Replacement of OR4P, OR4S, OR7, and OR11 in outrigger mechanism

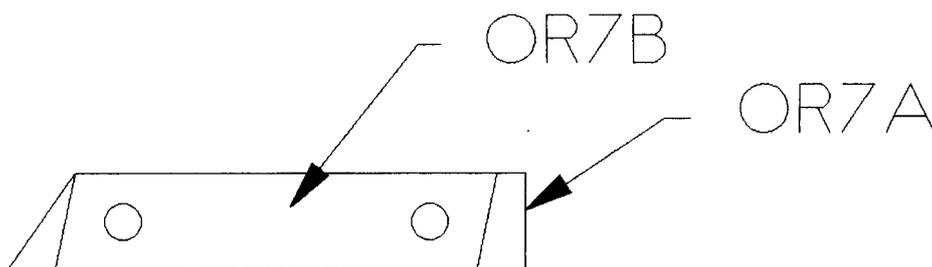
Remove the existing OR4 latch arms, OR7 latch blocks, and OR11 springs from the outriggers. Discard the springs as they are to be replaced by weaker springs.

There is no countersunk hole in the new OR4 latch arm so the MS24693-S58 countersink bolt will not be required. Use in its place an AN525-10R16 bolt.

Cut each of the original OR7*s along its length to remove the central 1/2" of material, and file the edges square. The new OR7B steel block is to be fitted here. Note that it is possible to fit OR7B any of four ways - only two are correct.

The angled end face of OR7B relative to OR7A should be as shown in the figure below.

Install the OR7A/OR7B sandwich back in the outrigger side plates then, having filed smooth the edges, install the OR4, filing the latching face to match the angle of OR7B.
